RECORD SET OF DRAWINGS
This set of drawings is provided by the Contractor as a schematic of the project in place. The Architect has not verified these conditions and is not responsible for conclusions drawn therefrom.
CHERRY/SEE ARCHITECTS 11/2/97 msc

TITLE: PHIL CHACON PARK PHASE I
SITE BOUNDARY SURVEY

Edith Cherry D. James See Architects <small>220 A. Road SW, Albuquerque, New Mexico, 87102 505.262.0211</small>	
CITY OF ALBUQUERQUE PARKS AND GENERAL SERVICES DESIGN & DEVELOPMENT DIVISION	
TITLE: AS BUILT CHANGES	
Design Review Committee	City Engineer Approval
City Project No. 4723.01	Zone Map No. L-18-Z
Sheet 26	Of 26

Sheet A-1

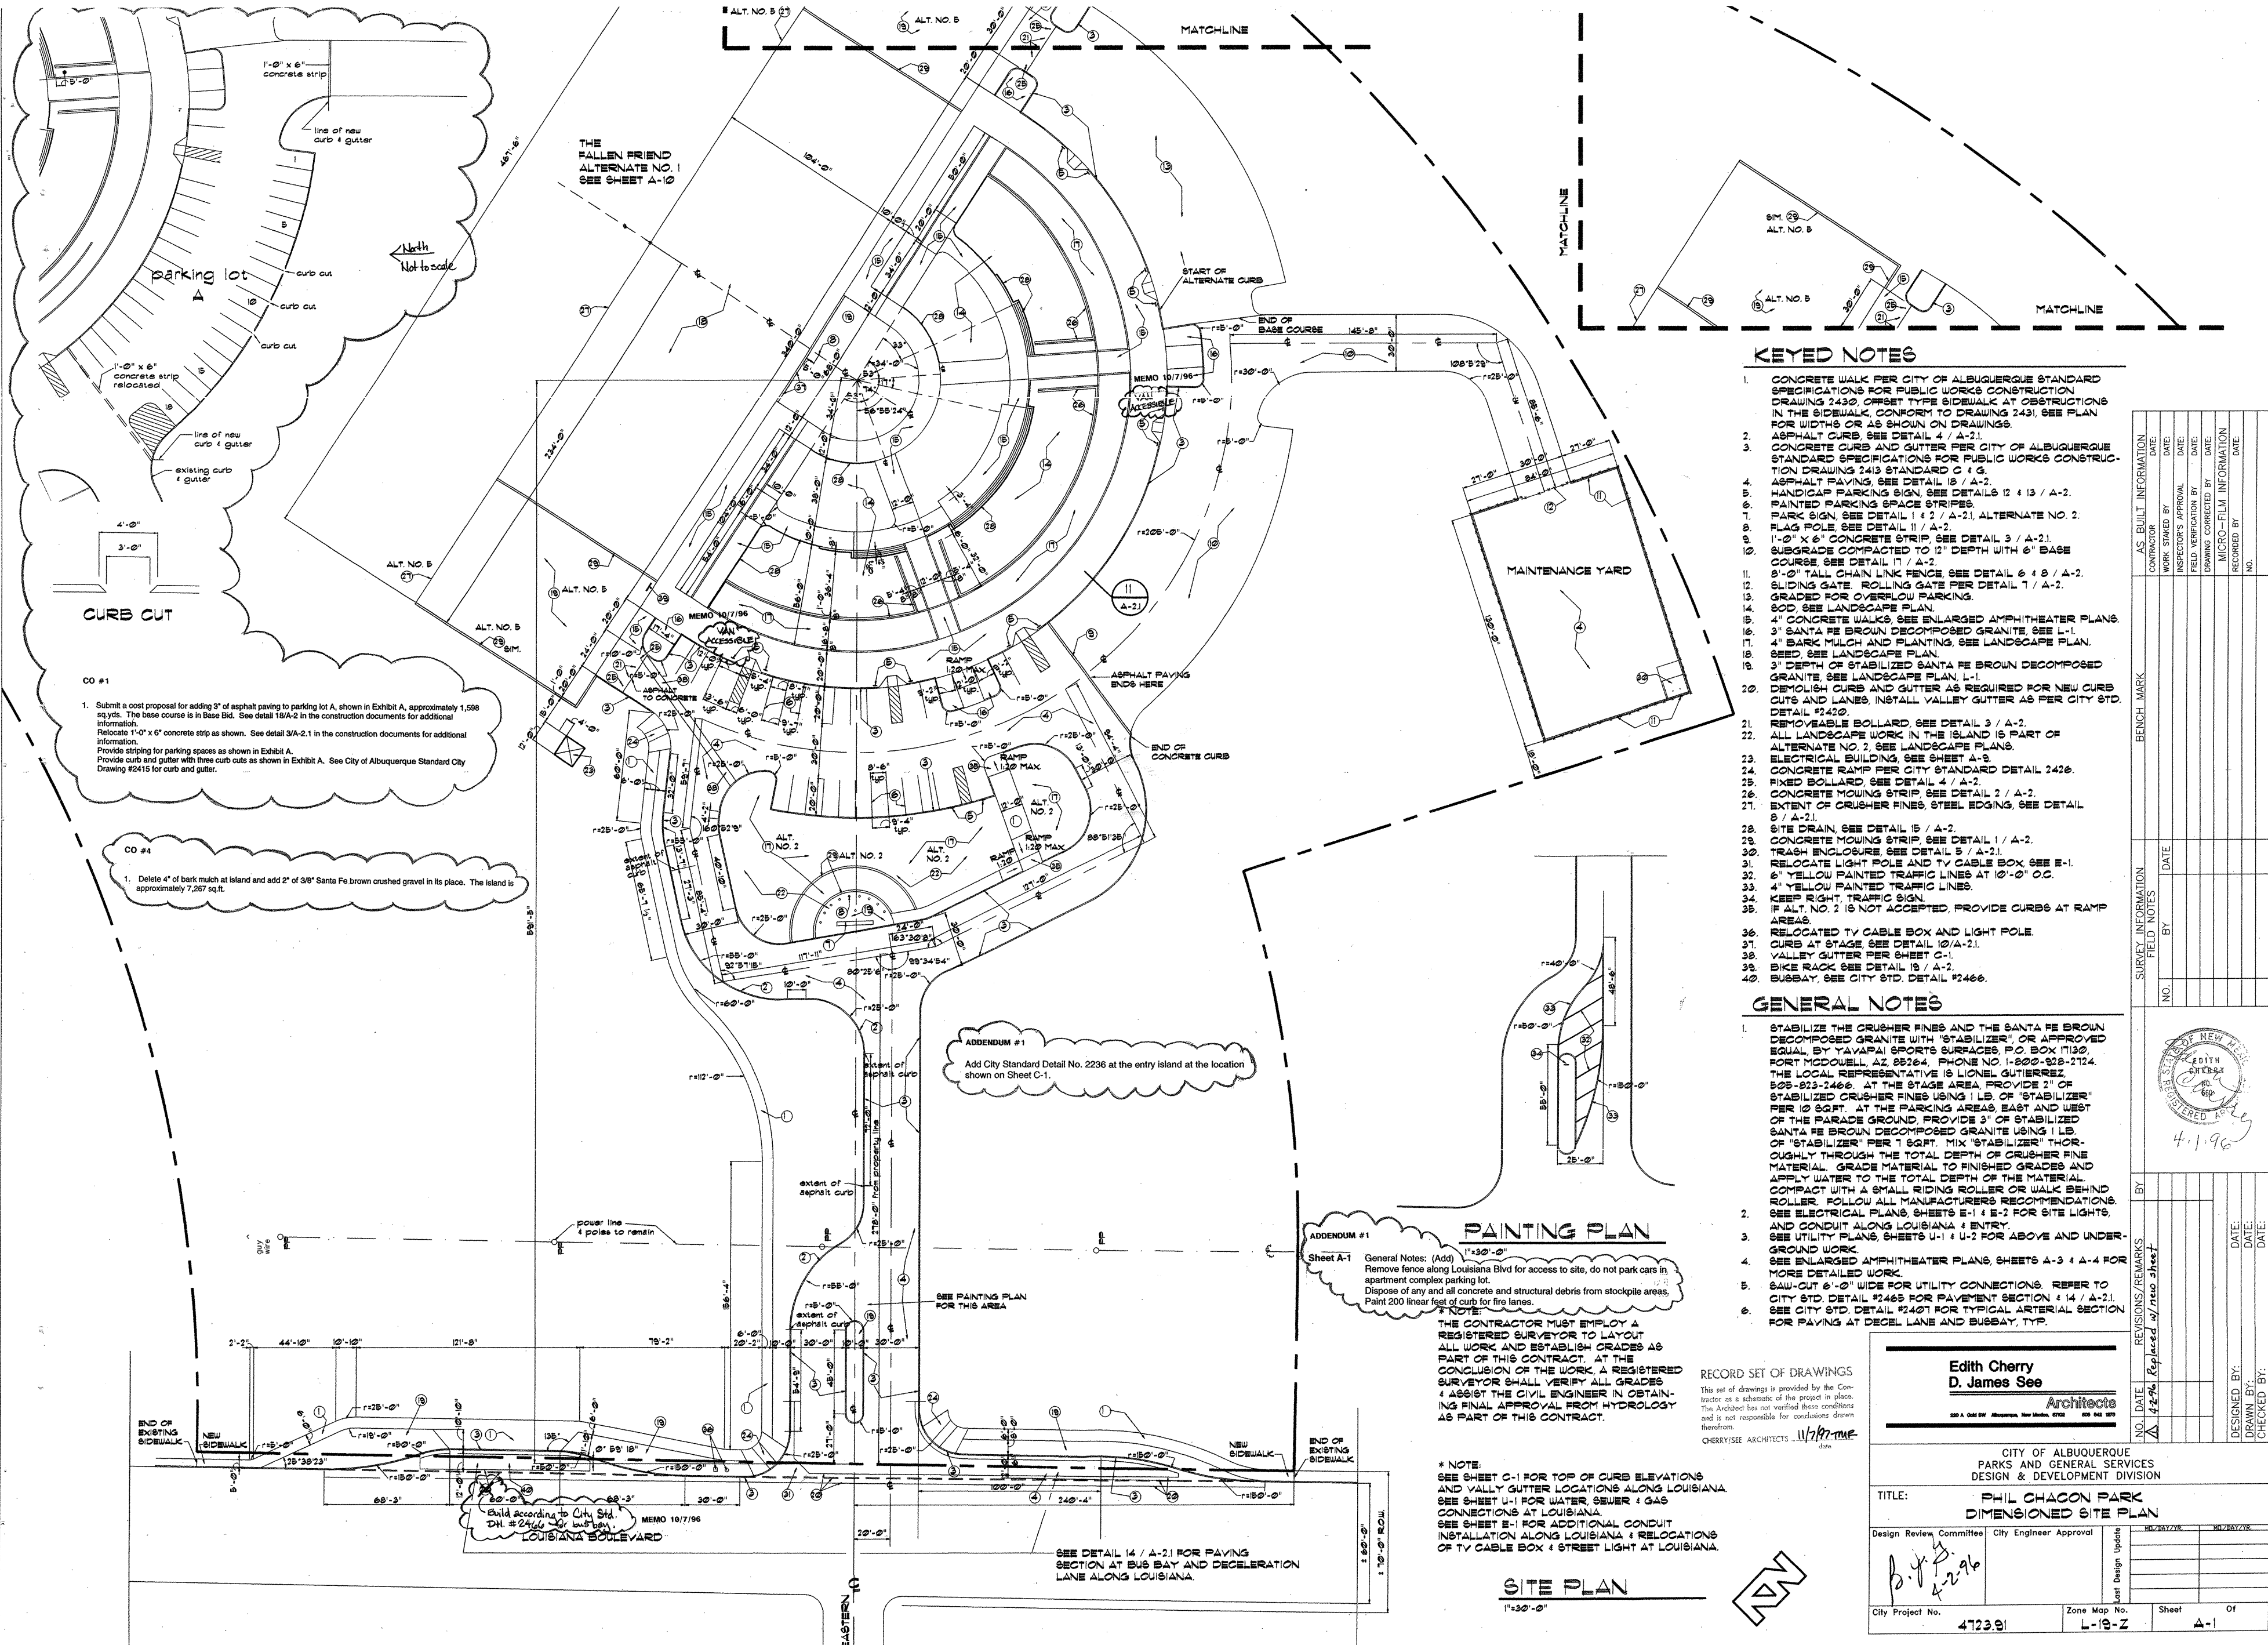
Sheet A-1
General Notes: (Add)
Remove fence along Louisiana Blvd for access to site, do not park cars in apartment complex parking lot.
Dispose of any and all concrete and structural debris from stockpile areas. Paint 200 linear feet of curb for fire lanes.

City Project No. 4723.91 Zone Map No. L-19-Z Sheet L-1 OF

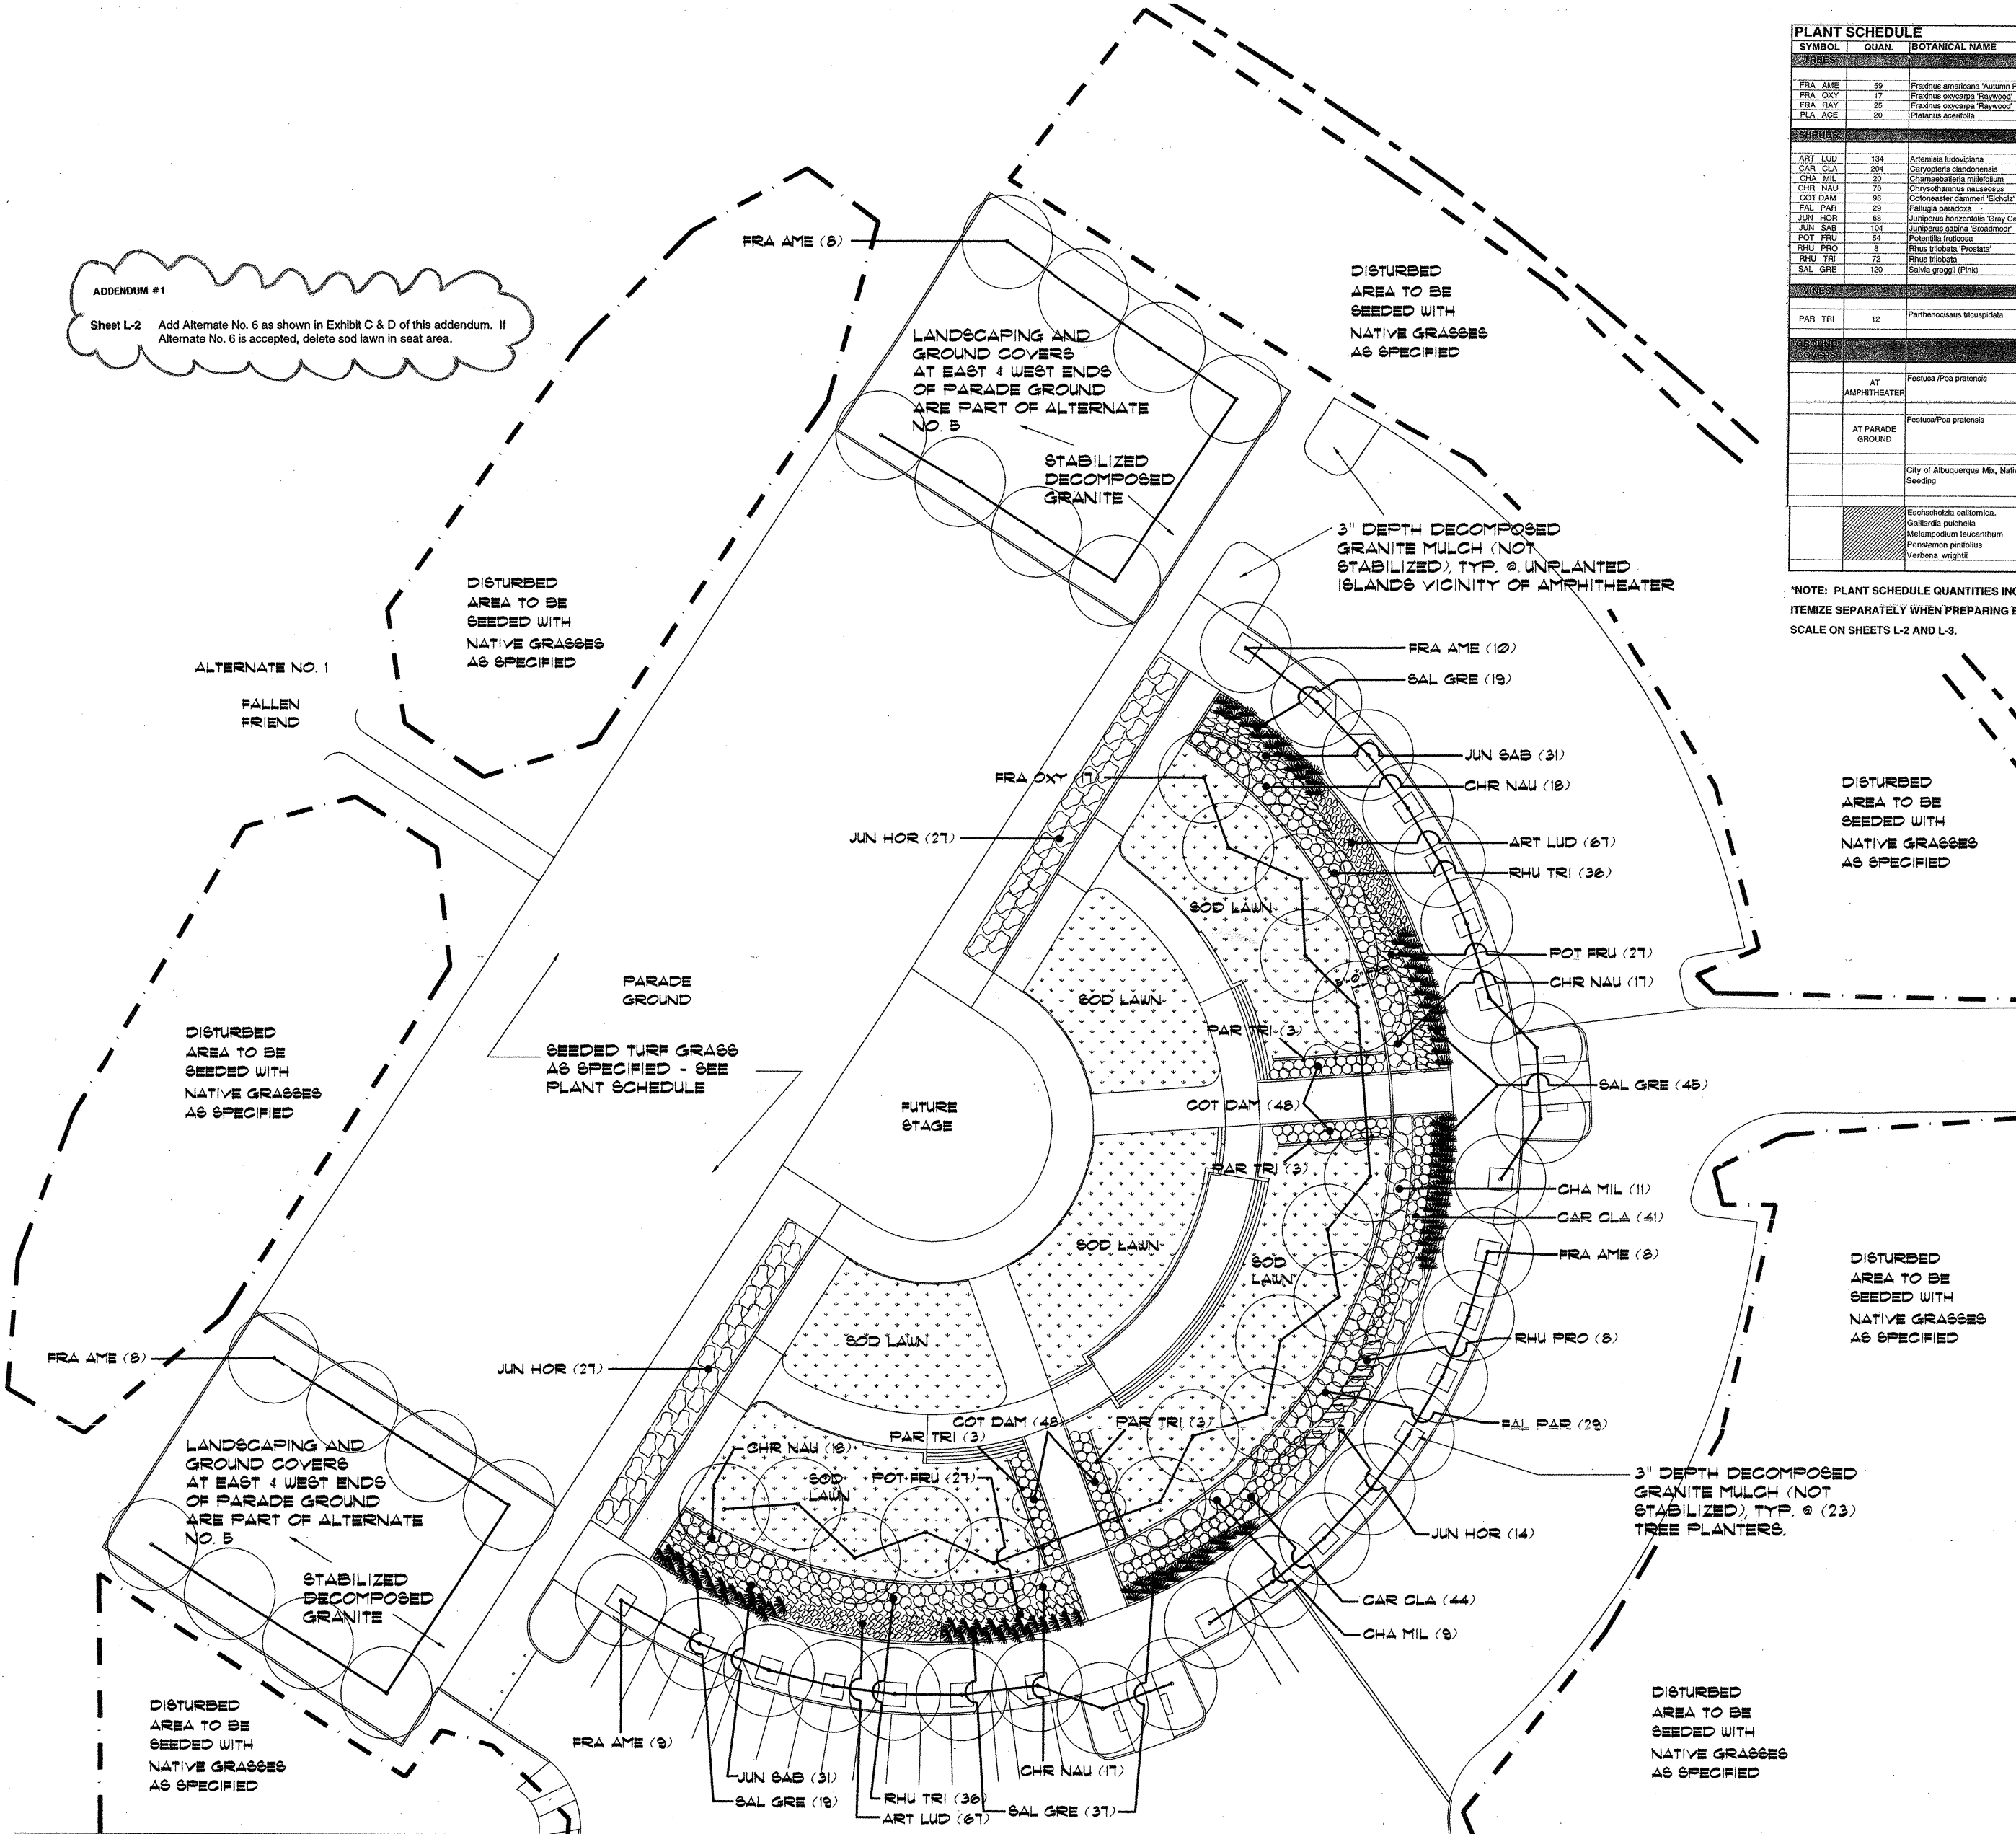
Sheet L-1 Add Alternate No. 6 as shown in Exhibit C & D of this addendum. If Alternate No. 6 is accepted, delete sod lawn in seat area.

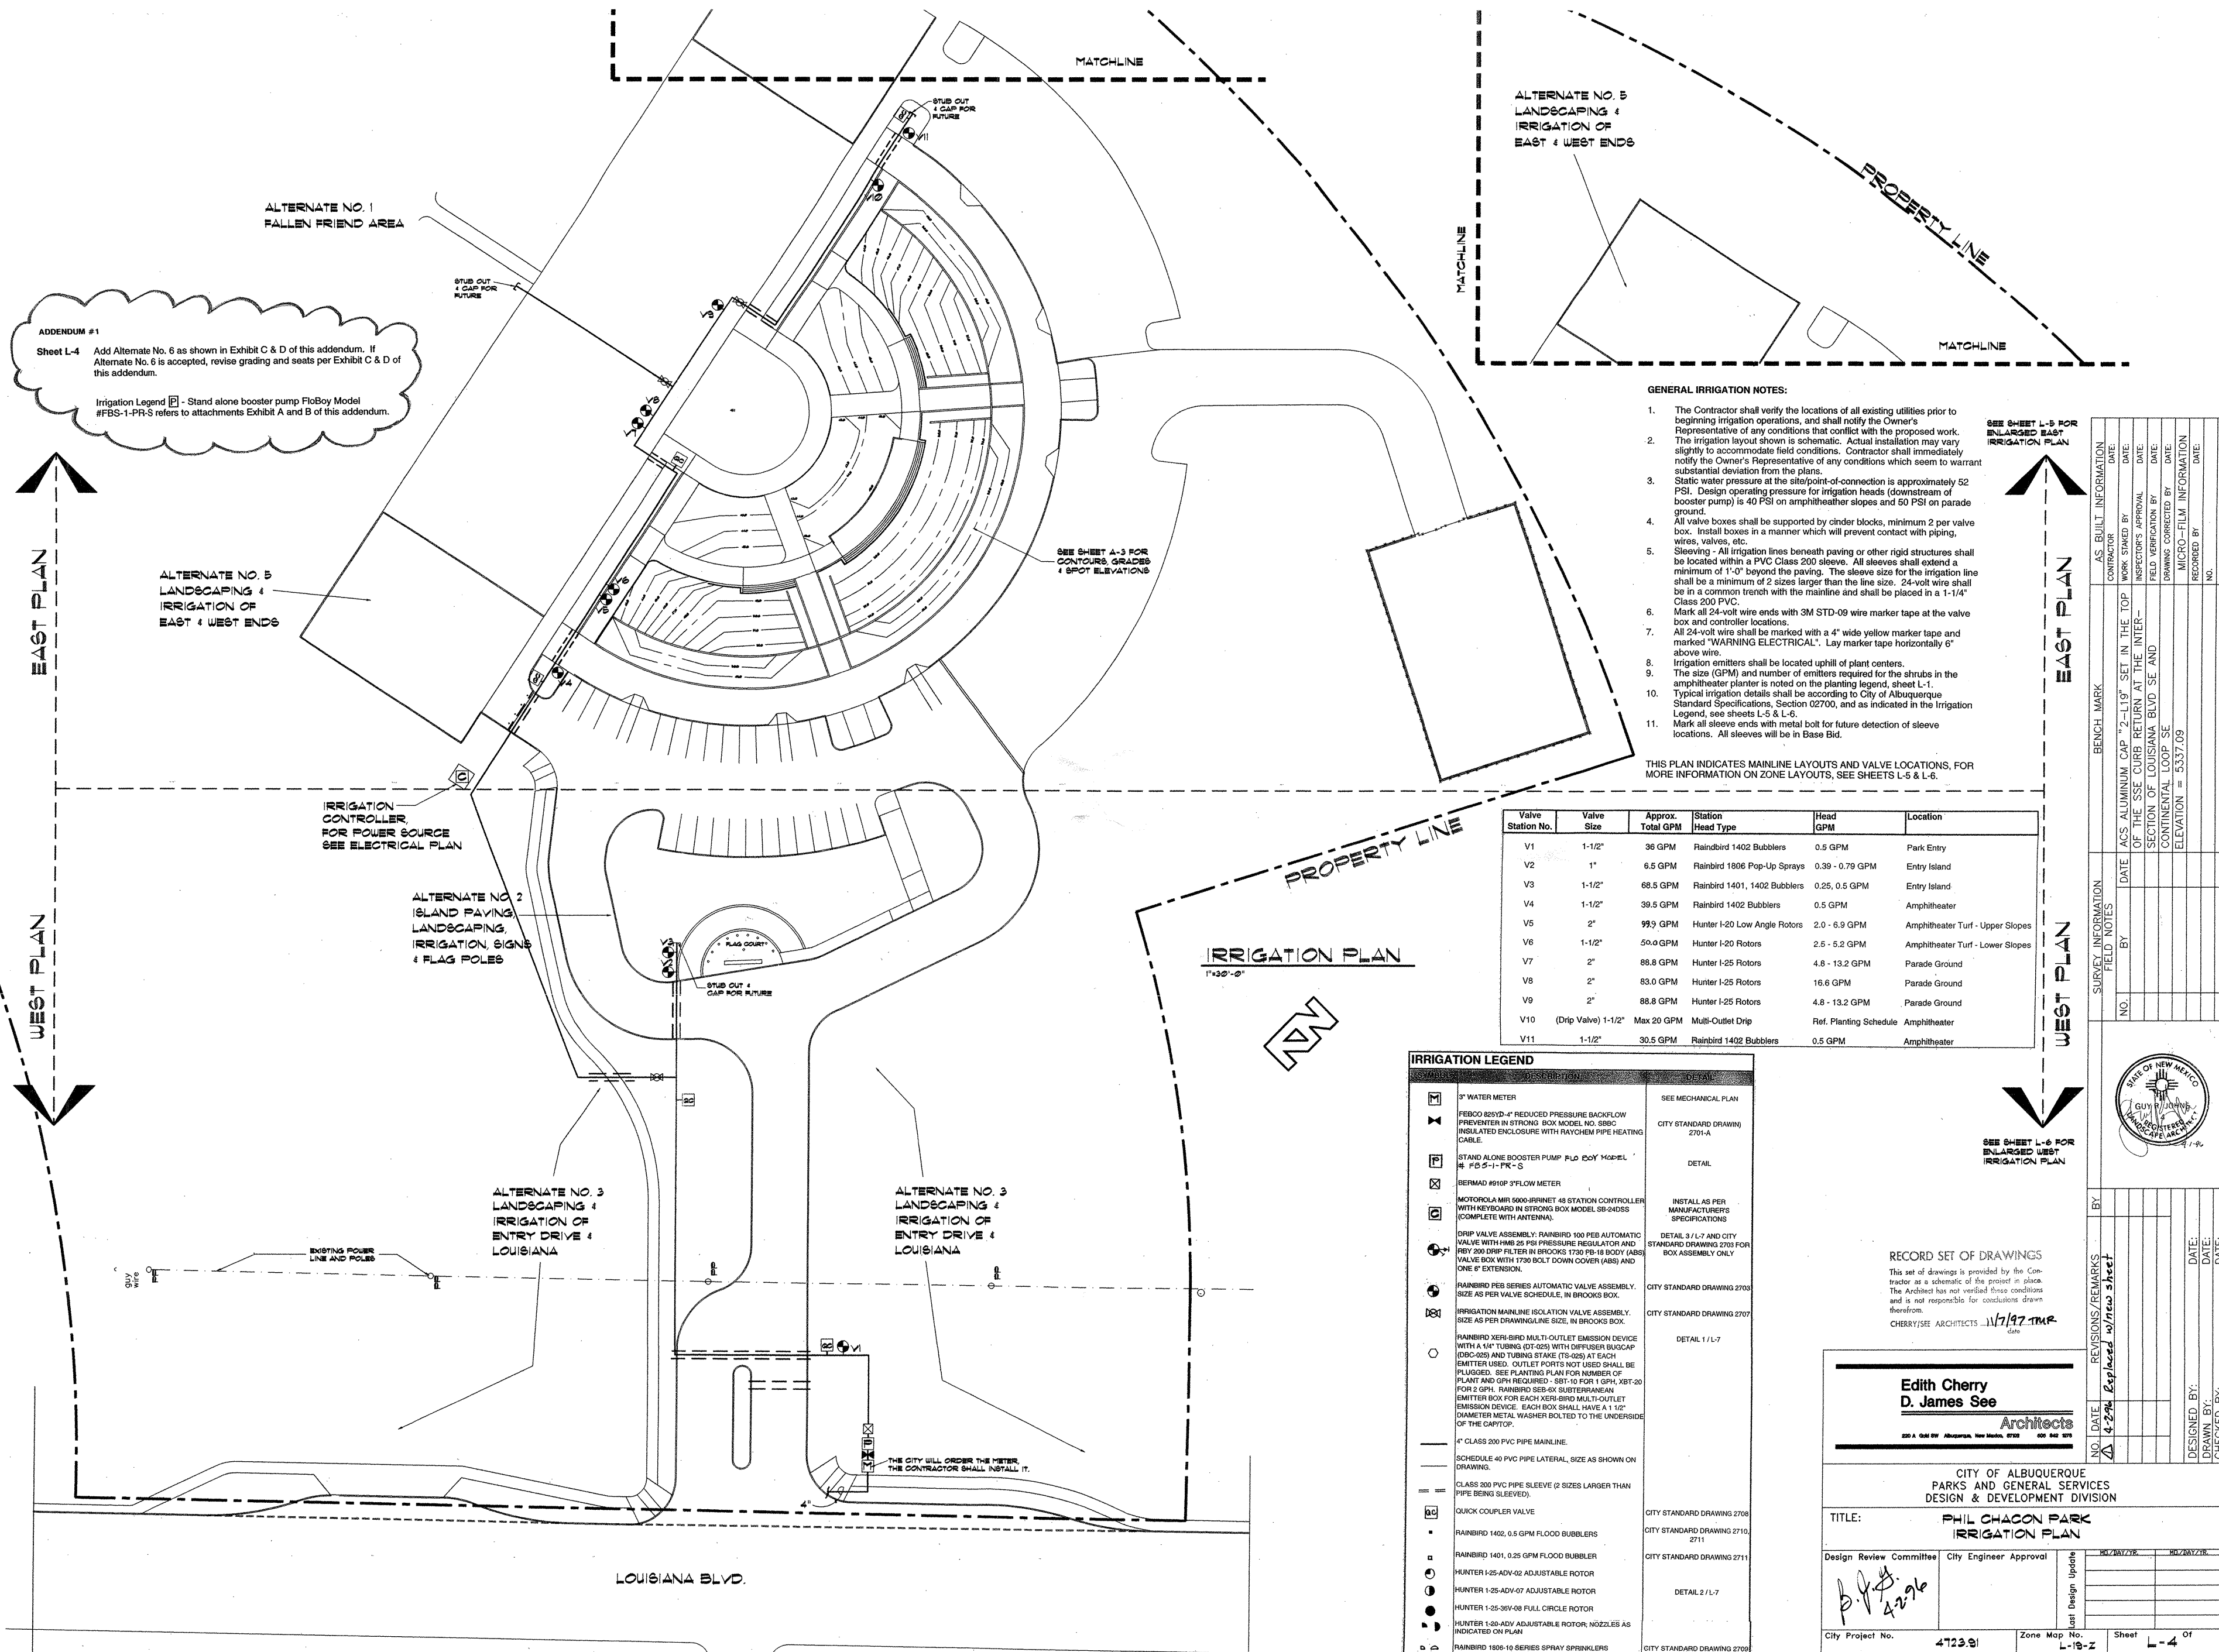
ADDENDUM #1
Sheet L-4 Add Alternate No. 6 as shown in Exhibit C & D of this addendum. If Alternate No. 6 is accepted, revise grading and seats per Exhibit C & D of this addendum.
Irrigation Legend [P] - Stand alone booster pump FloBoy Model #FBS-1-PR-S refers to attachments Exhibit A and B of this addendum.
